AMENDMENT

ETS 300 347-1

A1

**Signalling Protocols and Switching (SPS);
V interfaces at the digital Local Exchange (LE);
V5.2 interface for support of Access Network (AN);
Part 1: V5.2 interface specification**

Figure 11: Link control functional model

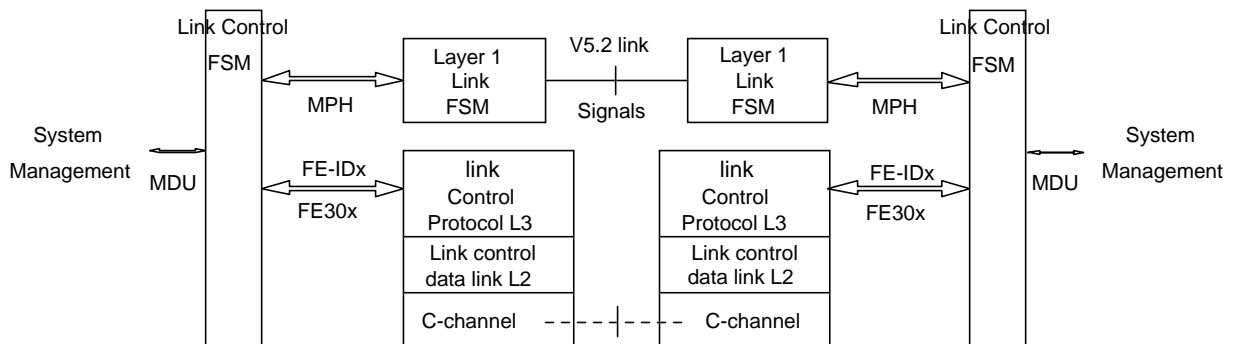
- Clause 16, figure 11: The invisible text is reconstituted from an earlier version.
- Subclause 16.2.4.5: A note is added about the sending of a notification to system management.

Add the formerly "invisible" text to figure 11:

Figure F.1: A possible AN/LE configuration using the V5 standard

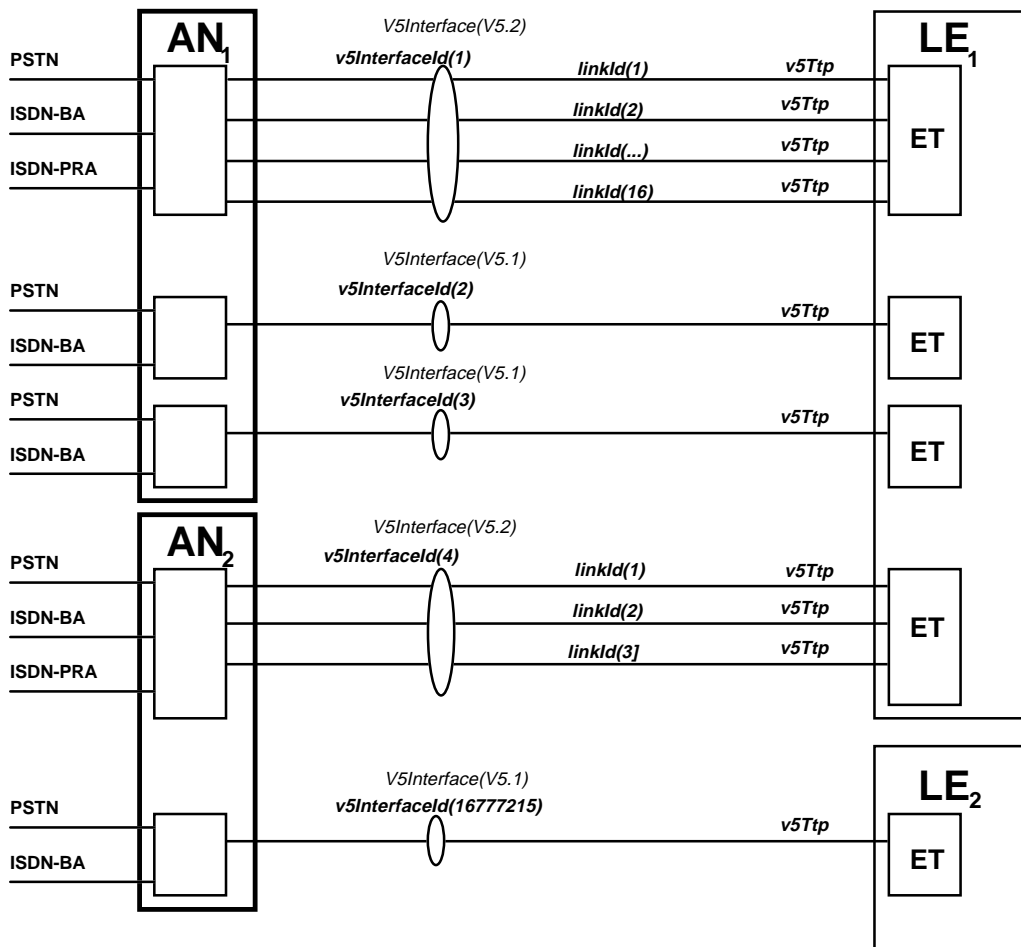
"F.4 Example of AN and LE configuration

Figure F.1 shows one case with two LEs and two ANs connected to each other via five V5 interfaces with the following given v5InterfaceID values: 1, 2, 3, 4, up to $2^{24}-1$, 16 777 215). LE₁ is connected to AN₁ and AN₂ using V5 interfaces of type both V5.1 and V5.2 to the same AN. Both LE₁ and LE₂ are connected to AN₂ using separate V5 interfaces of different types.

Page 163, figure L.6

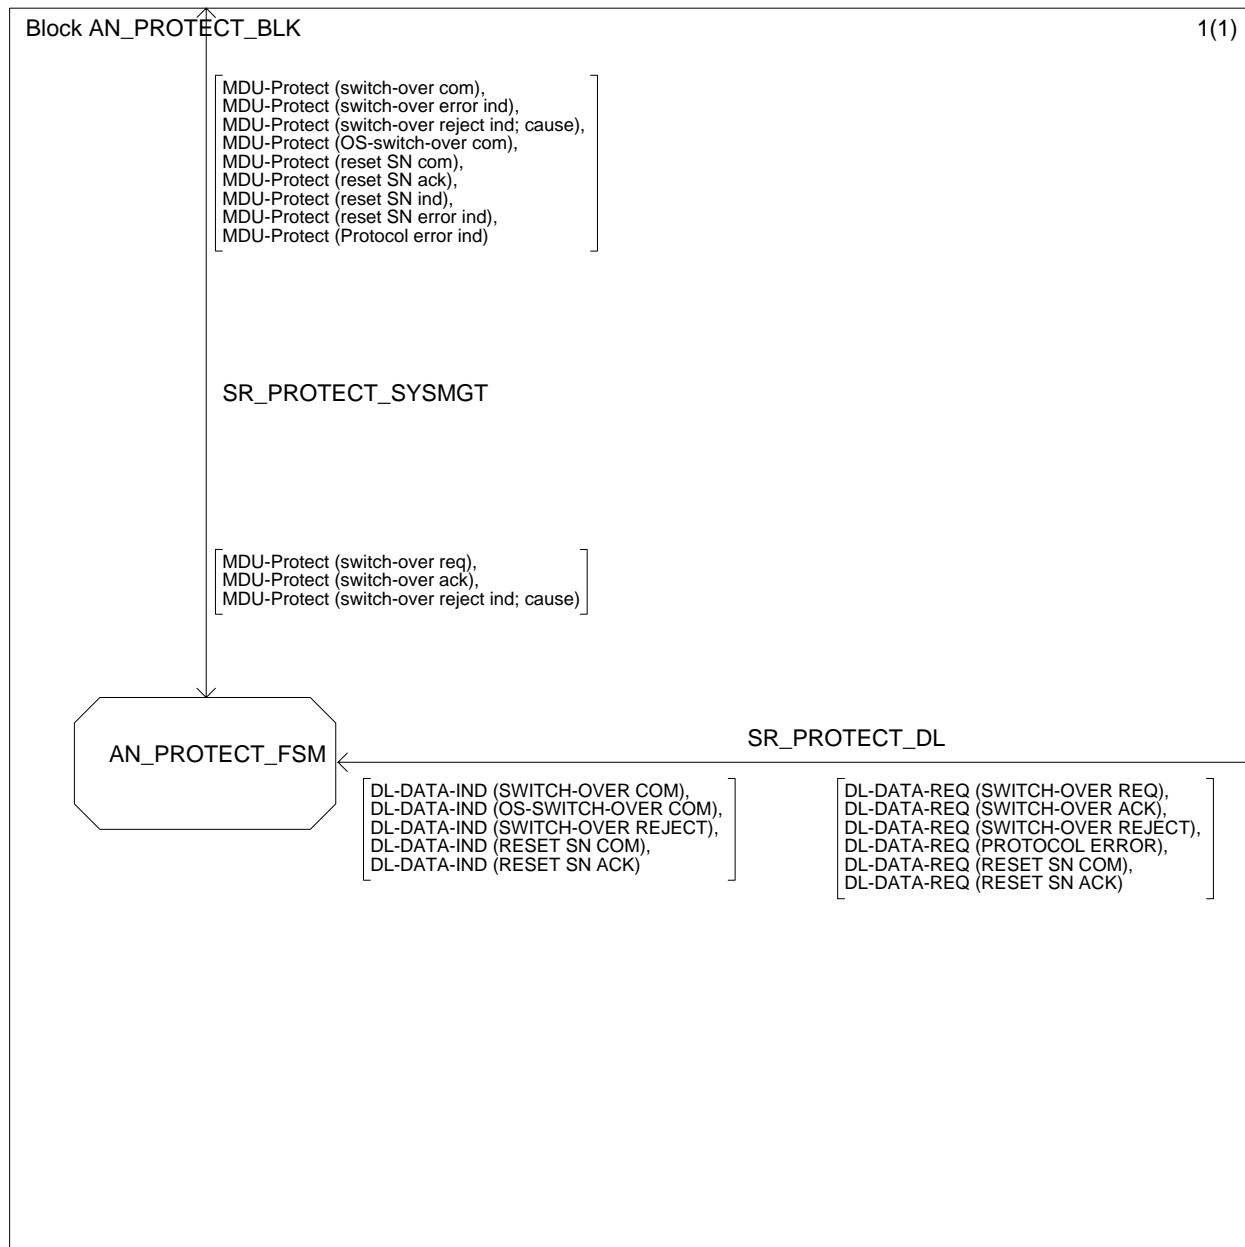
- Annex L, figure L.6: Some MDU-Protection primitives are missing for SR_PROTECT_SYSMGT: reset SN com, reset SN ind, reset SN ack and Protocol error indication.

Replace all prefixes of primitives for system management "MDU-Protection" by "MDU-Protect".

Replace "MDU-Protect(switch-over reject; cause)" by "MDU-Protect(switch-over reject ind; cause)".

Add the following MDU-Protection primitives for signal route SR_PROTECT_SYSMGT, upper signal list: OS-switch-over com, reset SN com, reset SN ack, reset SN ind, reset SN error ind and Protocol error ind.

Add the following PDU for signal route SR_PROTECT_DL, right signal list: PROTOCOL ERROR.

Page 194, figure L.13.4

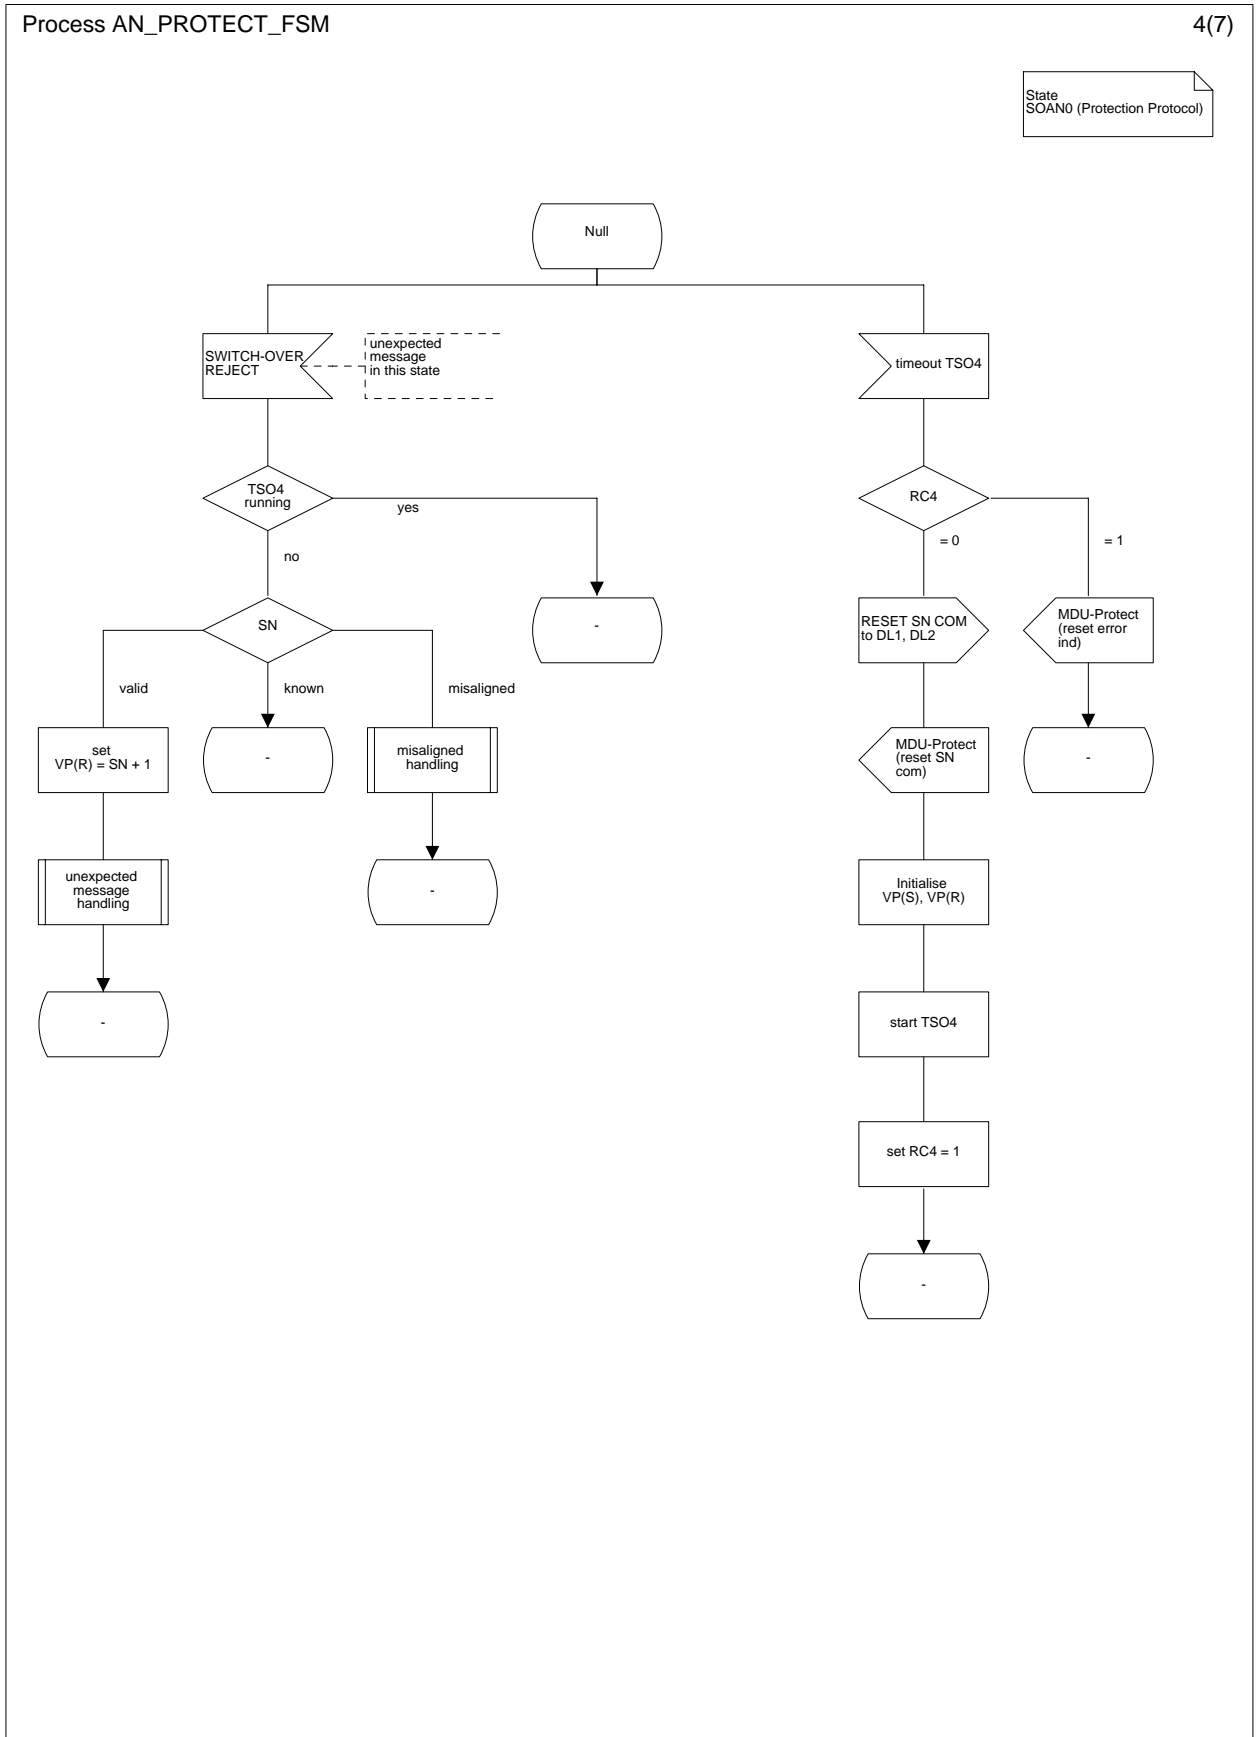
- Annex L, figure L.33.2: In the bottom diagram, the symbol for the message LINK CONTROL ACK has the wrong direction.
- Annex L, figure L.36.4: The cause for start of timer TSO4 is misalignment of sequence numbers VP(S) or VP(R) and repetition at the first timeout. Initialization of the sequence numbers V(P) or V(P) is only done in the procedure for misaligned handling according to figure L.14. This procedure is applied at the AN side and LE side.
When a misalignment is detected and TSO4 is running, there will be no further protocol messages apart from RESET SN COM. Therefore, the sequence numbers remain in their initialization values.
Amendment: Both figures L.13.4 and L.36.4 are corrected with a task symbol to initialize VP(S) and V(P) before start of TSO4.

Add the task symbol "initialize VP(S), VP(R)" before task symbol "start TSO4".

Page 200, figure L.15.2

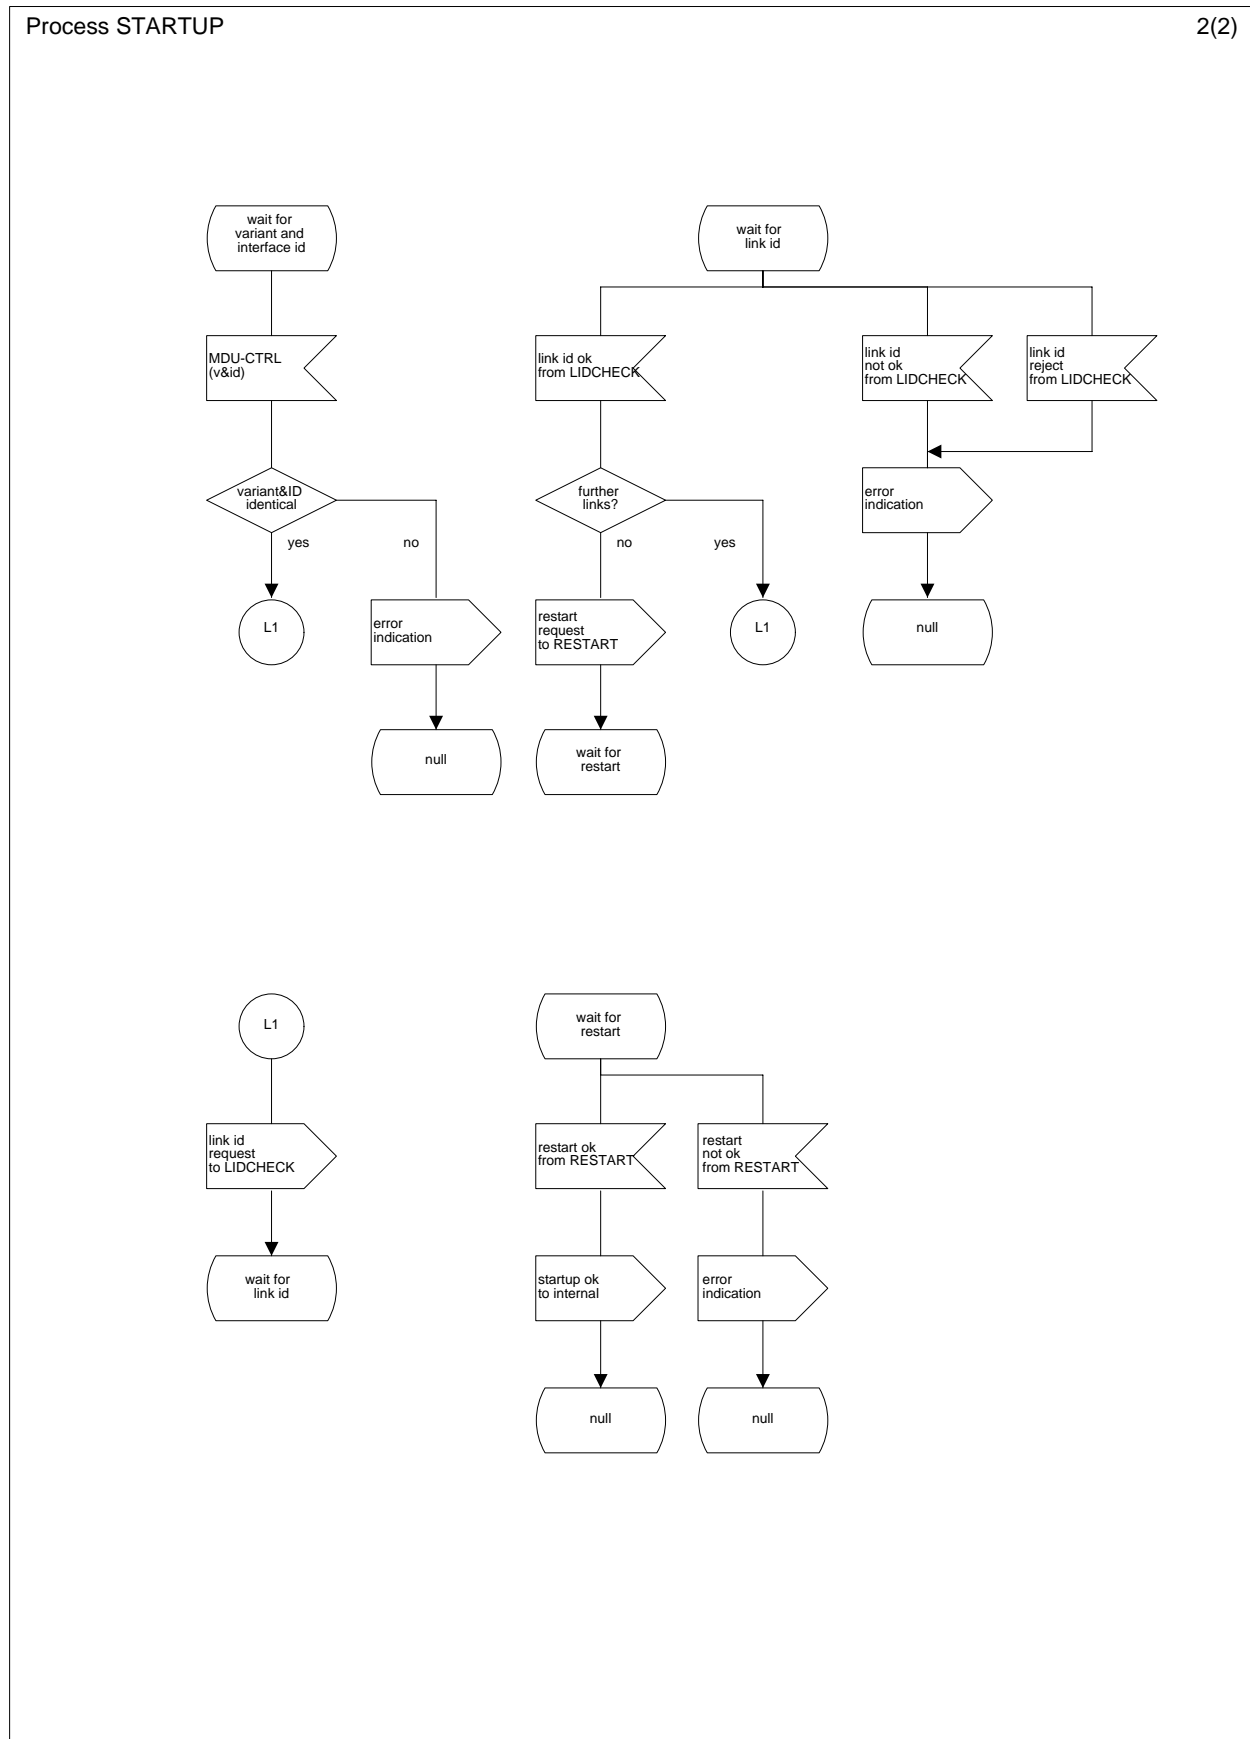
Annex L, figure L.15.2: Figure L.15.2 is contradictory to annex C, item 13), which requires that the variant and interface ID shall be checked during system start-up. Figure L.15.2 shows only a check of the interface ID.

Amendment: Update the figure by adding a decision for the correct variant.

Replace decision "ID identical" by "variant&interface ID identical".

Page 205, figure L.18.1

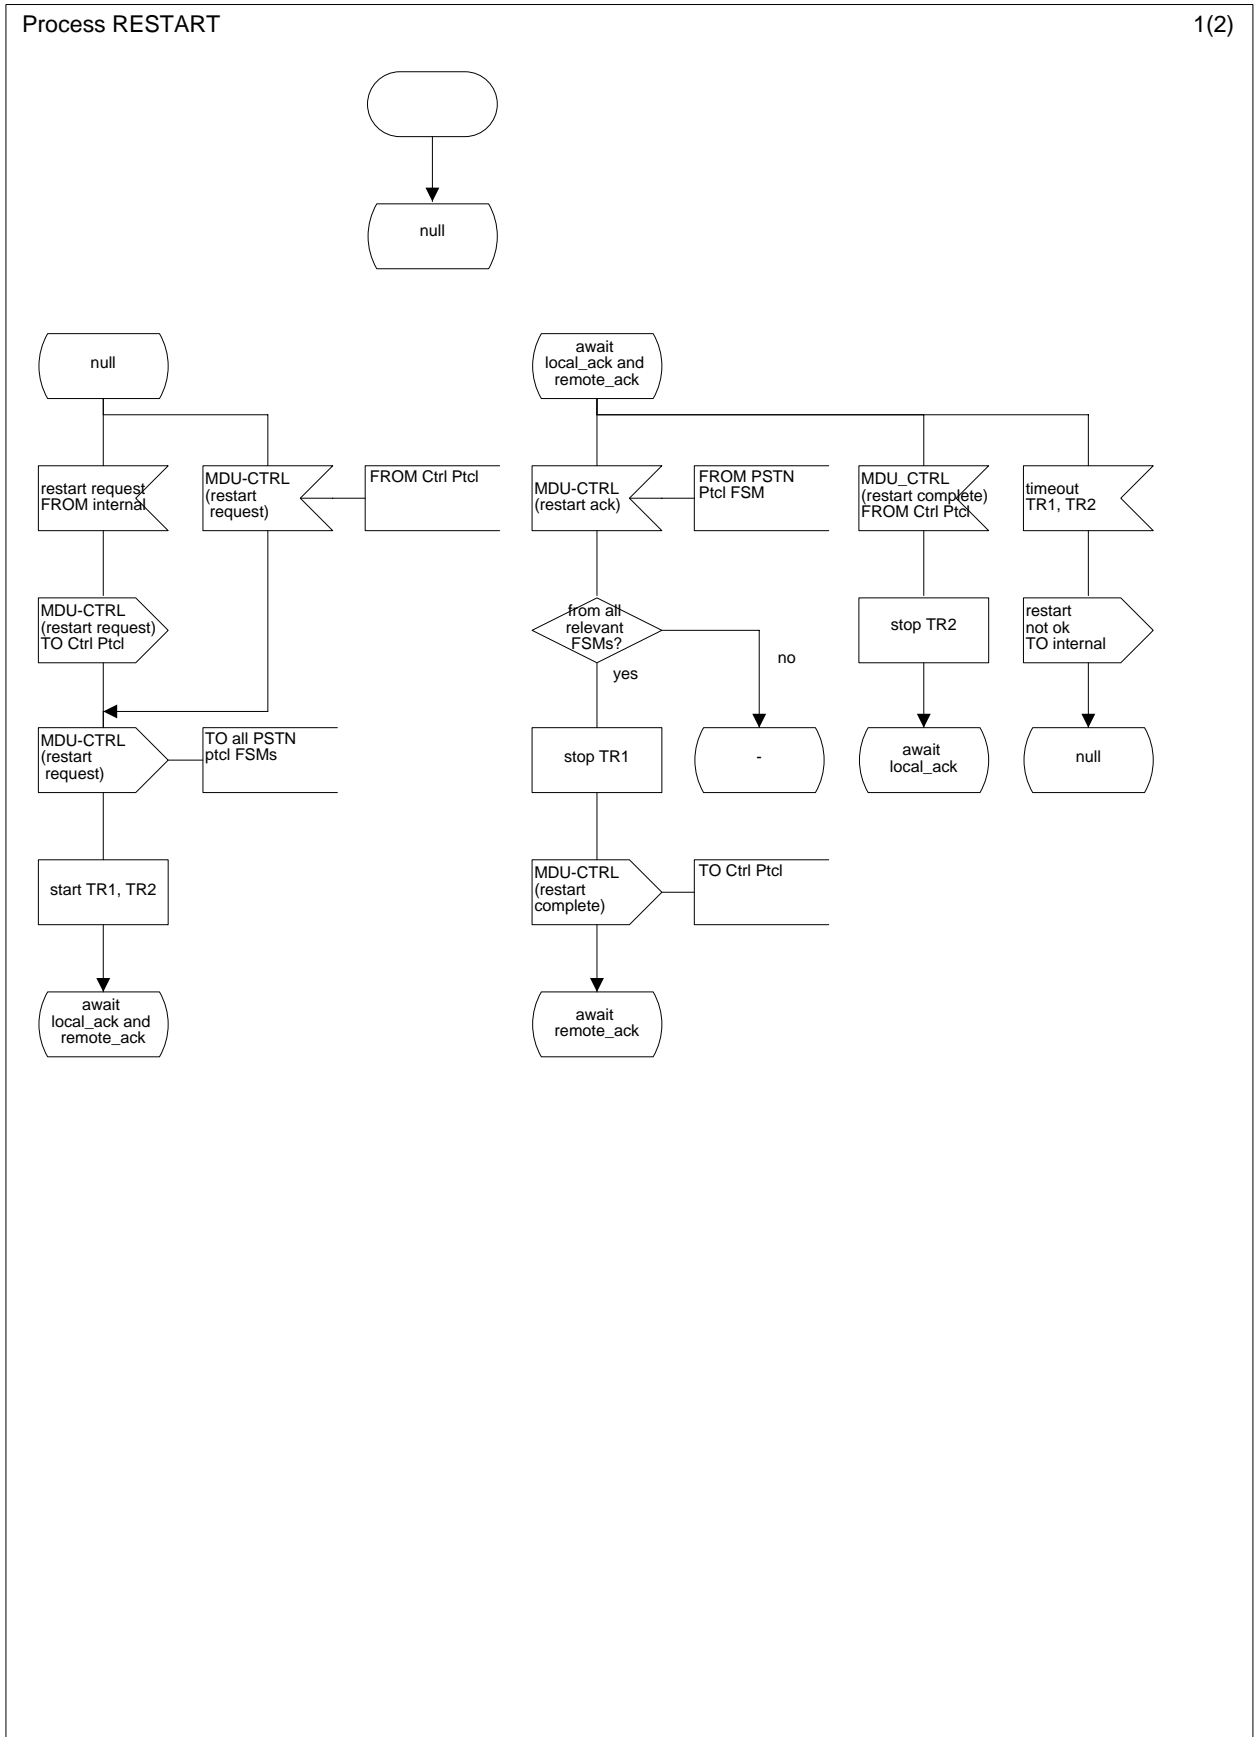
Replace the complete figure.
